TECHNICAL NOTE

ref 440

SD5, SD10, SD7 MIXERS LCD Solo Button replacement types

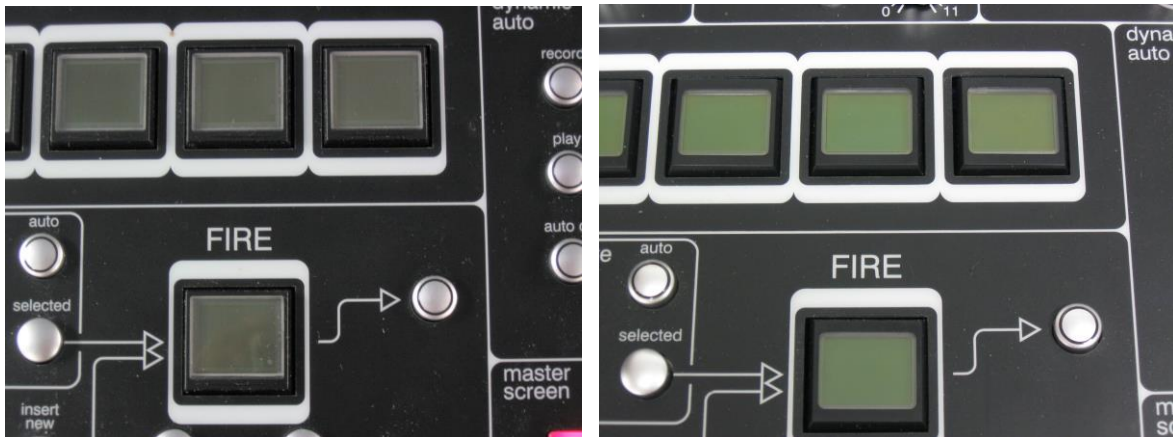
The original buttons used for early SD5 (also SD10 smart keys) have been discontinued. Later mixers use, or have buttons that are compatible in style with, the SD7 button.

The basic difference is cosmetic and so we avoid mixing the 2 types on 1 panel.

The old SD5 button looks different and is SW000121. These are no longer obtainable new. Note how the older button has a slimmer bezel (black edge around the window).

The current buttons for SD5 and SD10 are part number SW000116A .

All buttons with the later style bezel can be replaced with SW000116A

Note on SD5 as the "fire" button is separate this can be swapped for the new pattern as this considered satisfactory cosmetically.

Otherwise, all SD5, SD10 and SD7 repairs are covered by SW000116A.
